DOCKETED	
Docket Number:	21-AFC-02
Project Title:	Willow Rock Energy Storage Center
TN #:	260808
Document Title:	Willow Rock Data Request Set 5 Response Report
Description:	N/A
Filer:	Kathryn Stevens
Organization:	WSP USA Inc.
Submitter Role:	Applicant Consultant
Submission Date:	12/23/2024 4:09:42 PM
Docketed Date:	12/23/2024

Willow Rock Energy Storage Center (21-AFC-02)

Data Request Response Set 5

ATTACHMENT DR116-1

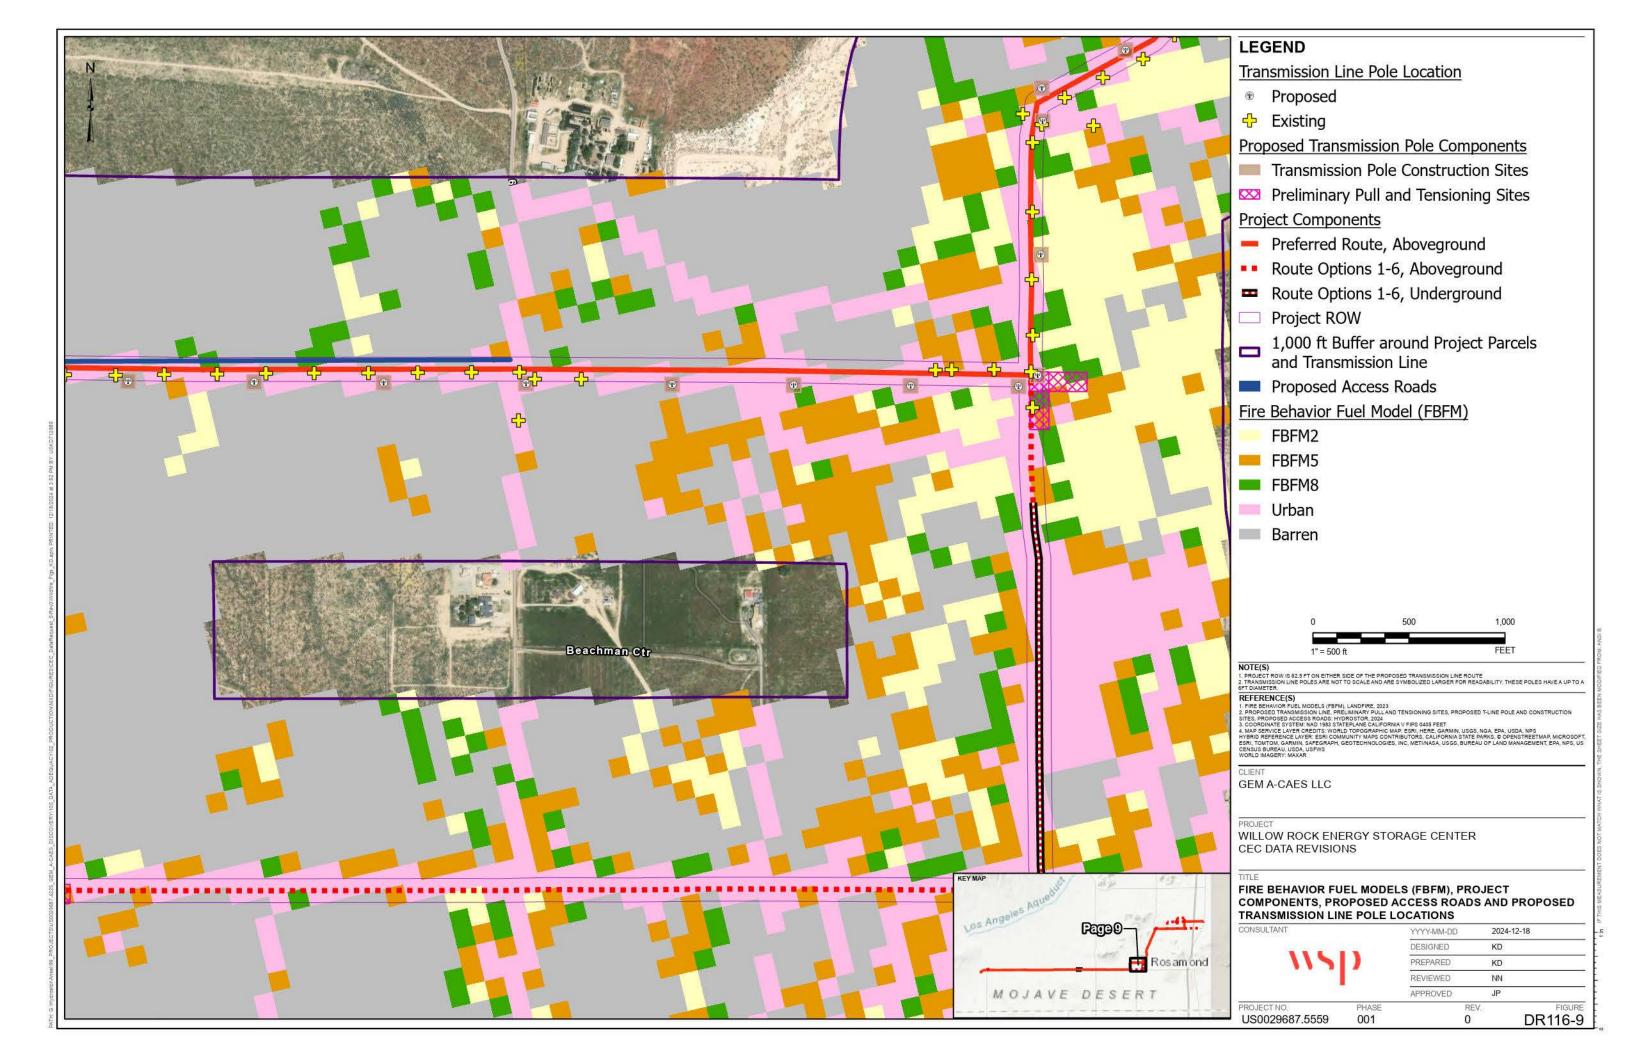
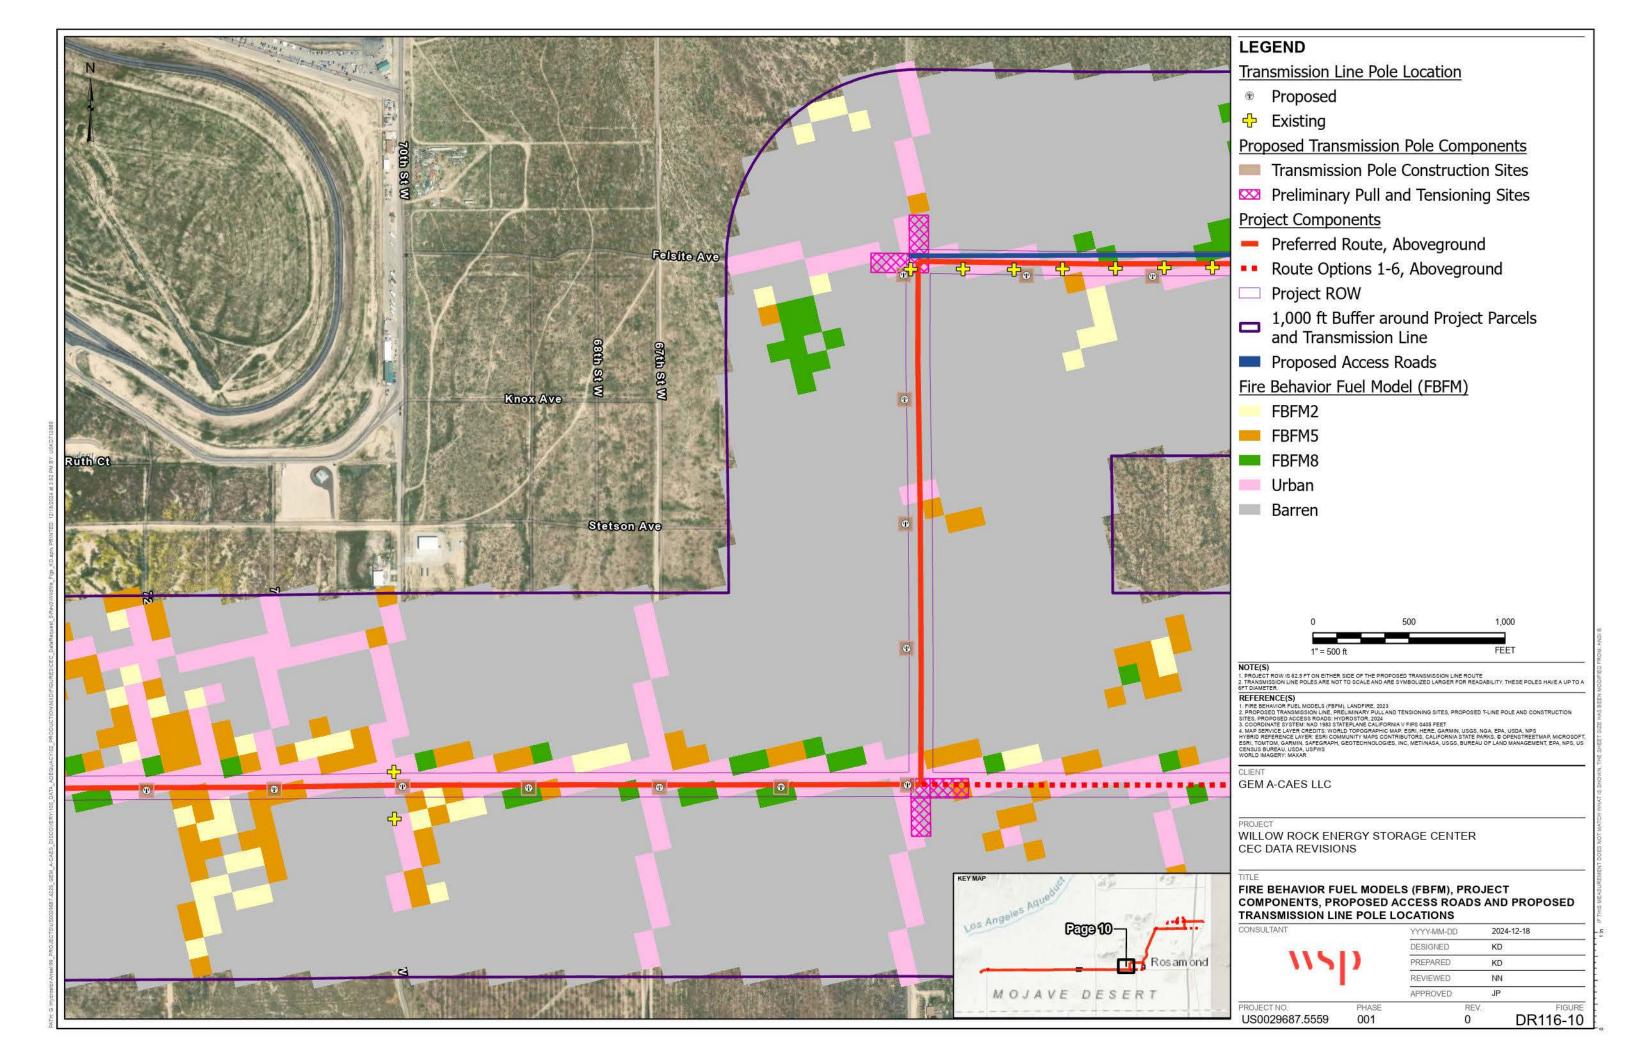
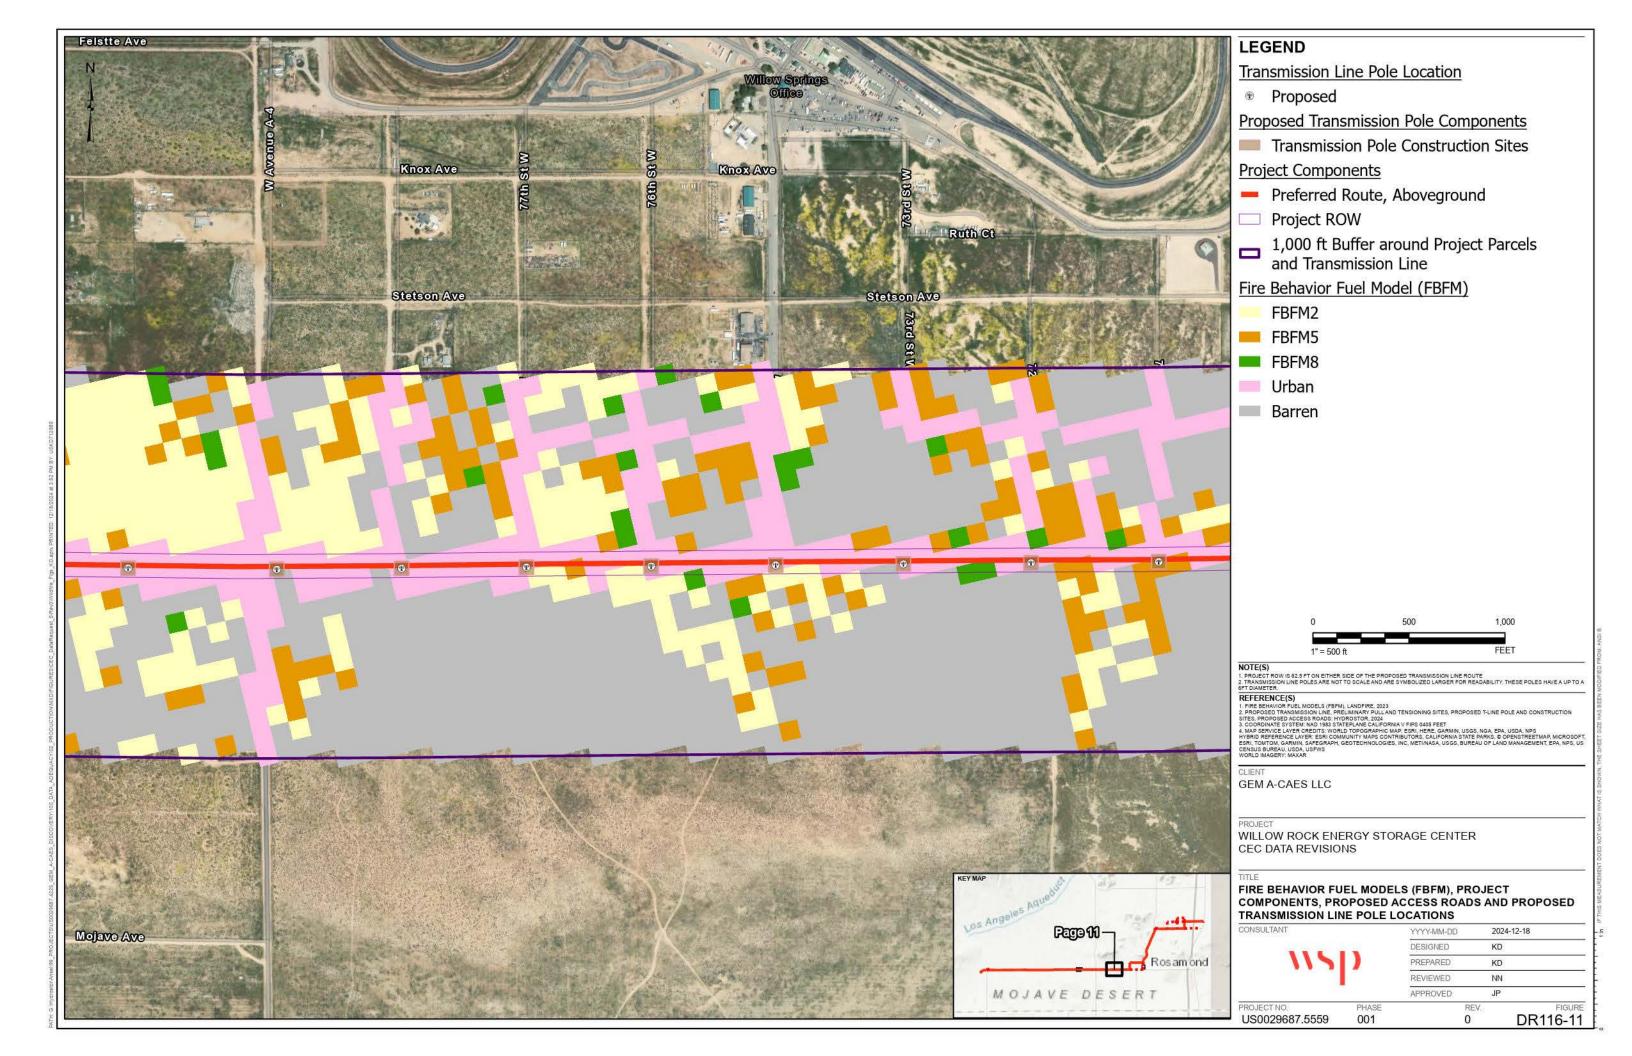
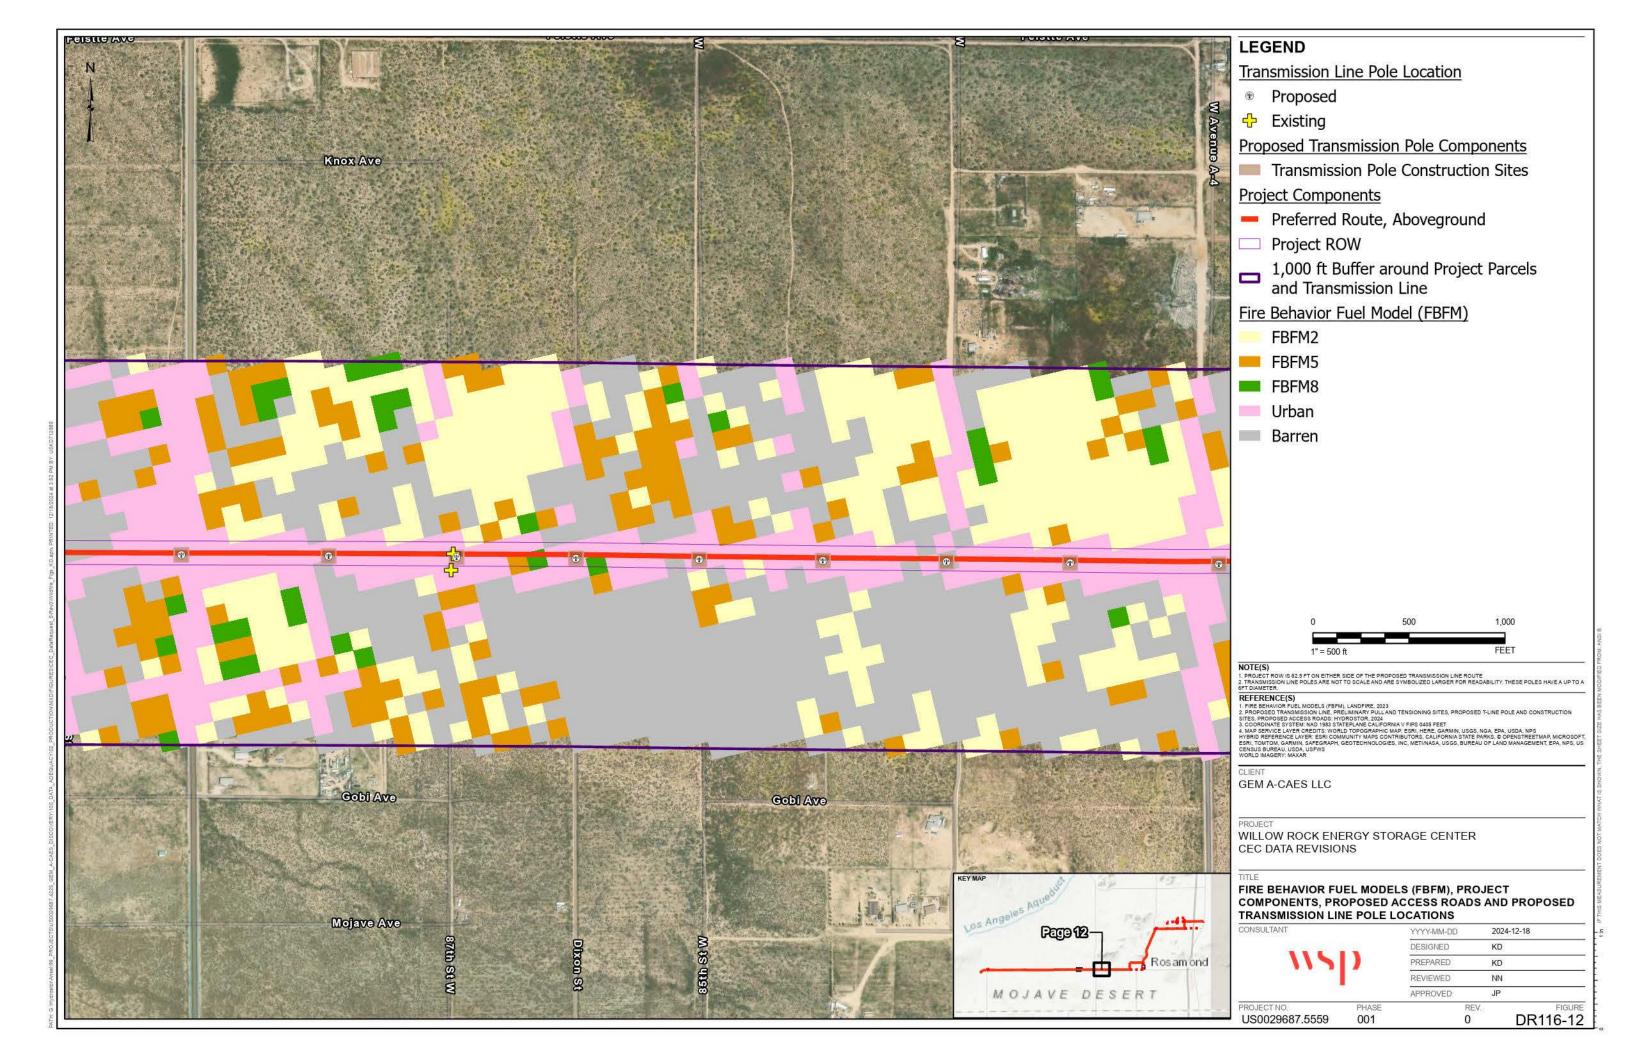
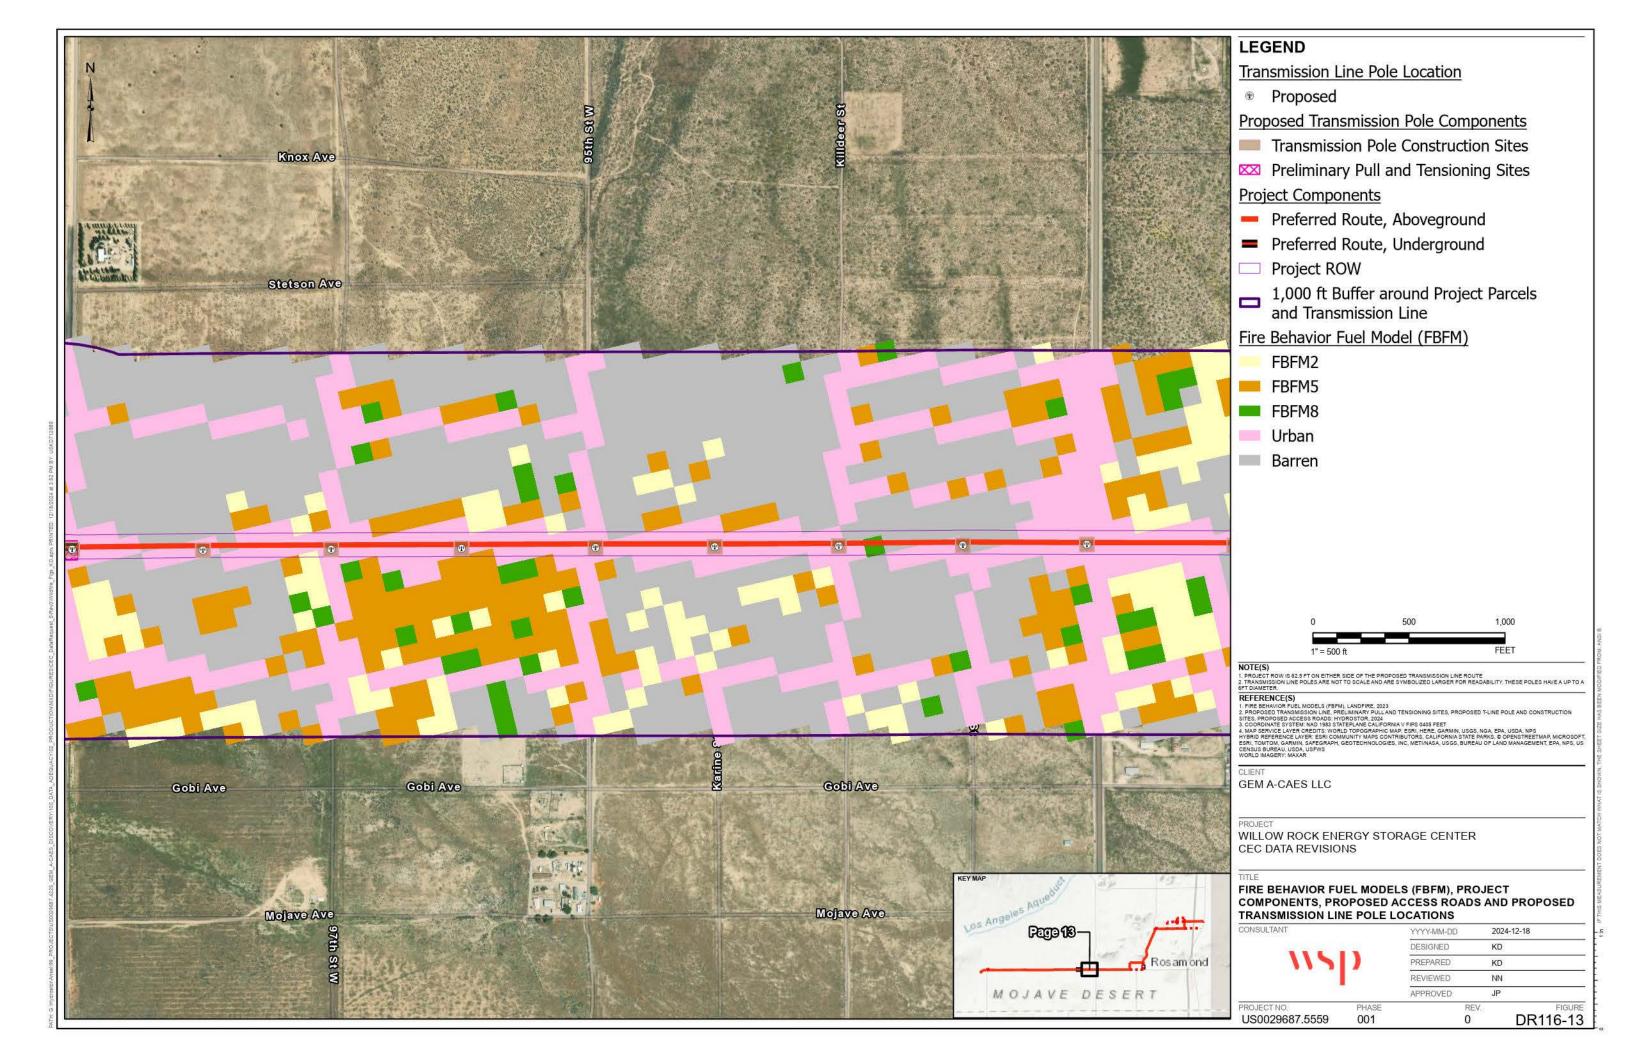
DR116: Provide a discussion and map that indicates how each identified Fuel Model relates to the project specifically and where they are in relation to each component of the project, including the transmission line.

Attachment DR116-1 provides a map showing the relevant fuel models in relationship to project components. The following describes how each fuel model geographically relates to the Project:

- Based on data from LANDFIRE, the fire behavior fuel models (FBFM) surrounding the transmission line and Project components are FBFM2, FBFM5, and FBFM8.
- FBFM2 dominates the area on the eastern side of the WRESC site.
- FBFM5 and FBFM8 make up the areas to the west of the WRESC site along Dawn Road.

- FBFM2 dominates the area surrounding Mojave Tropico Road.
- The majority of Rosamond Boulevard is surrounded by urban areas that do not include an FBFM, however FBFM2, FBFM5, and FBFM8 are dispersed along some sections of the road, with FBFM5 being the most dominant.
- The Whirlwind Substation is mostly surrounded by FBFM2, however, both FBFM5 and FBFM8 occur on the northeast side of the substation.
- The majority of existing and proposed transmission line poles are located in urban areas that are not classified with an FBFM.
- The majority of pull and tensioning sites overlap with FBFM2, FBFM5, or FBFM8.
